Title: AN APPARATUS AND METHOD FOR
MANIPULATION OF AN OBJECT

REQUEST FOR CERTIFICATE OF CORRECTION OF OFFICE MISTAKE (35 U.S.C. §254, 37 CFR §1.322)

PATENT NO. : 6,798,120

FIG._2

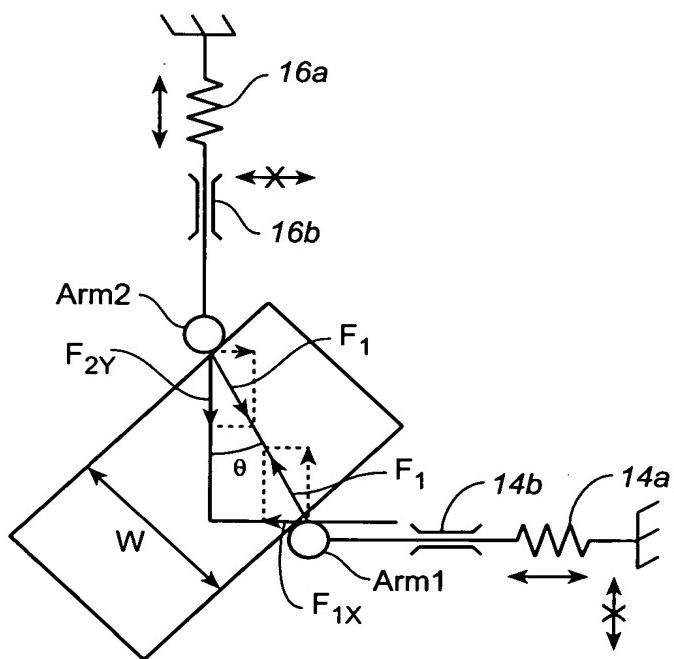
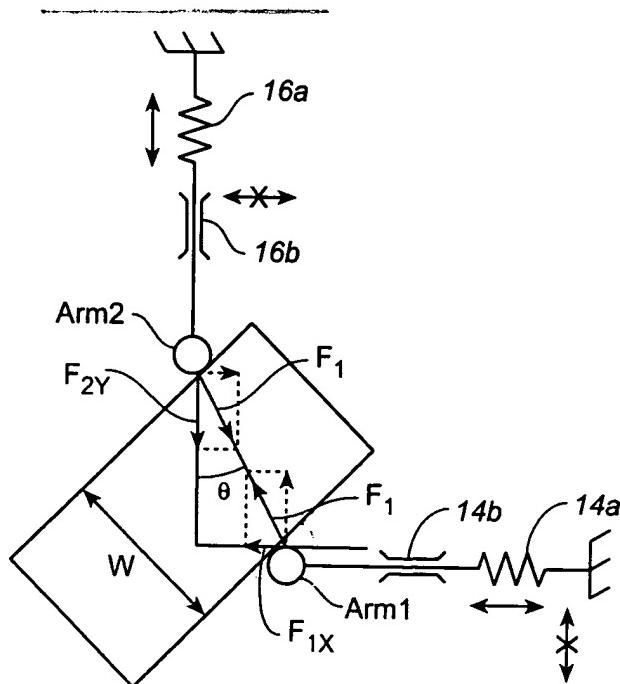
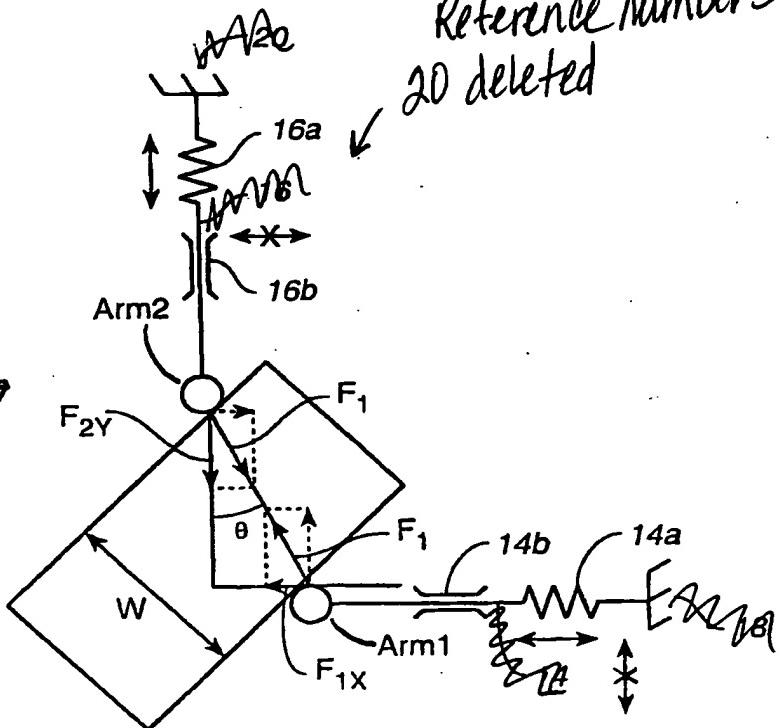
1. The attached replacement sheets of drawings include changes to Figures 2 and 7A-7C. These sheets replaced the original sheets that included Figures 2 and 7A-7C. In Figure 2, reference numbers 14, 16, 18 and 20 were deleted, and lead lines were added for Arm 1 and Arm 2. In Figures 7A-7C, reference numbers 14 and 16 were replaced by reference numbers 14a and 16a, and reference numbers 14b and 16b were added.

In the drawings, Sheet 1, Fig. 2, is replaced by the attached Replacement Sheet 1. Sheet 5, Figs. 7A, 7B, 7C, are replaced by the attached Replacement Sheet 5. In Fig. 2, reference numbers 14, 16, 18 and 20 have been deleted, and lead lines have been added for Arm 1 and Arm 2. In Figs. 7A-7C, reference numbers 14 and 16 have been replaced by reference numbers 14a and 16a, and reference numbers 14b and 16b have been added.

The attached sheets of drawings include changes to Figures 2 and 7A-7C. These sheets replace the original sheets that included Figures 2 and 7A-7C. In Figure 2, reference numbers 14, 16, 18 and 20 have been deleted, and lead lines have been added for Arm 1 and Arm 2. In Figures 7A-7C, reference numbers 14 and 16 have been replaced by reference numbers 14a and 16a, and reference numbers 14b ad 16b have been added.

Reference numbers 14, 16, 18 and
 20 deleted

Lead lines added for
 Arm 1 and Arm 2 →

Figure 2 schematically represents the equivalent stiffness of the beam 14, the x-arm, and the beam 16, the y-arm. The bending stiffness of the beam 14 is substantially along the x direction and is represented by a virtual spring element 14a. The high stiffness which prevents

FIG._7A

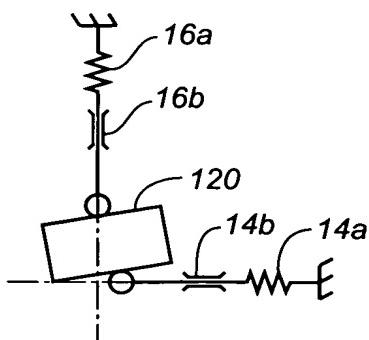
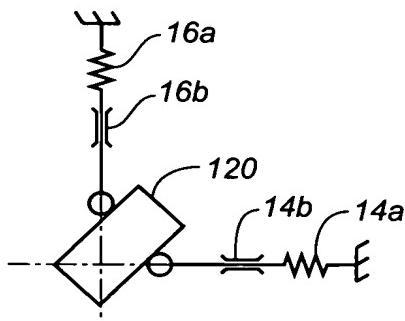
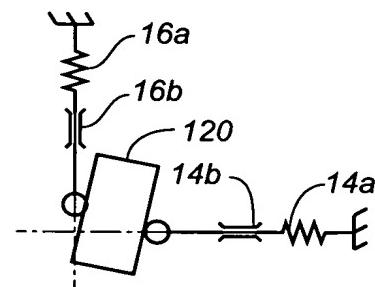
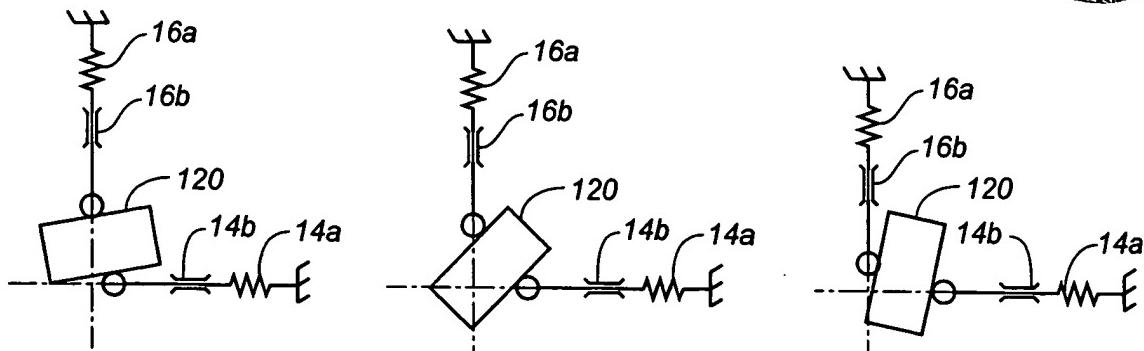
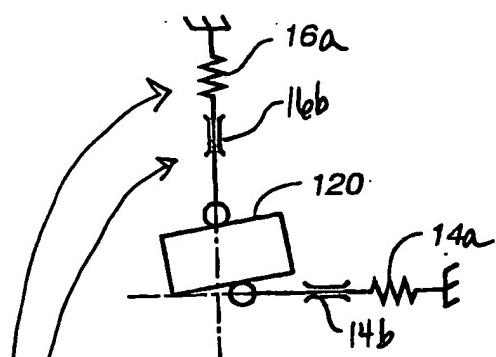
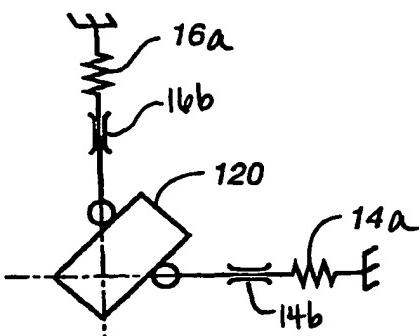
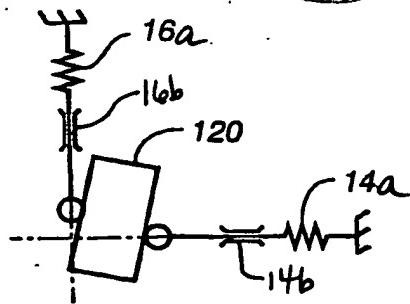
Reference numbers 14 and 16 replaced with reference numbers 14a and 16a, and reference numbers 14b and 16b have been added.

extension of the beam 14 in the y direction is represented by a virtual constraint element 14b. The bending stiffness of the beam 16 is substantially along the y direction is represented by a virtual spring element 16a. The high stiffness which prevents extension of the beam 16 in the x direction is represented by a virtual constraint element 16b.

Figure 2 showing schematic representation of equivalent beam stiffness.

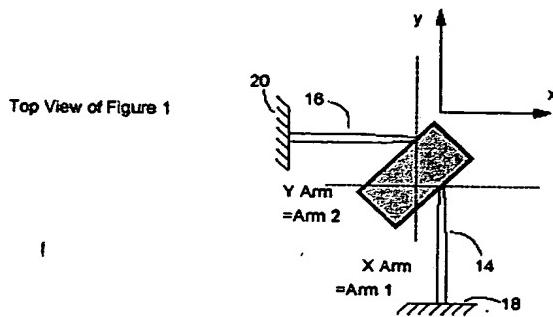
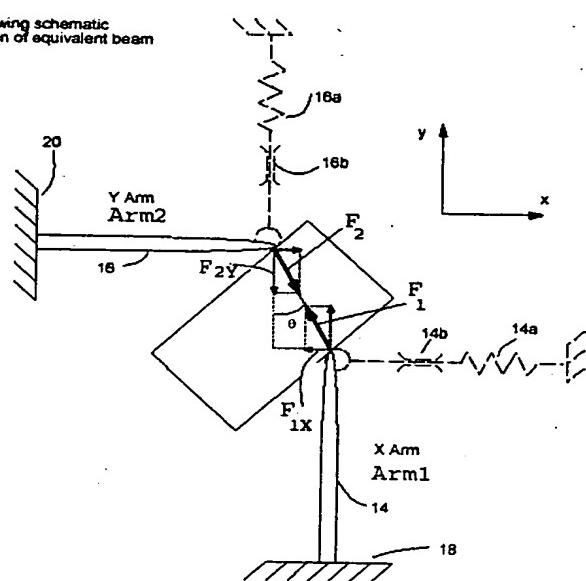
The claims pending in the subject application, claims 1-26, stand rejected under 35 U.S.C. 112. According to the examiner, there is a conflict in what is shown in Figures 1 and 2.

By way of further explanation, a simplified plan view of the system of Figure 1 of the subject specification is shown below:

Combining this view of Figure 1 with that of Figure 2, as illustrated below, shows the schematic representation of the equivalent beam stiffness:

Thus, as can be seen from the subject specification, as well as from the above explanation, what is depicted in Figures 1 and 2 is consistent with the operation of the claimed apparatus for manipulating an object.
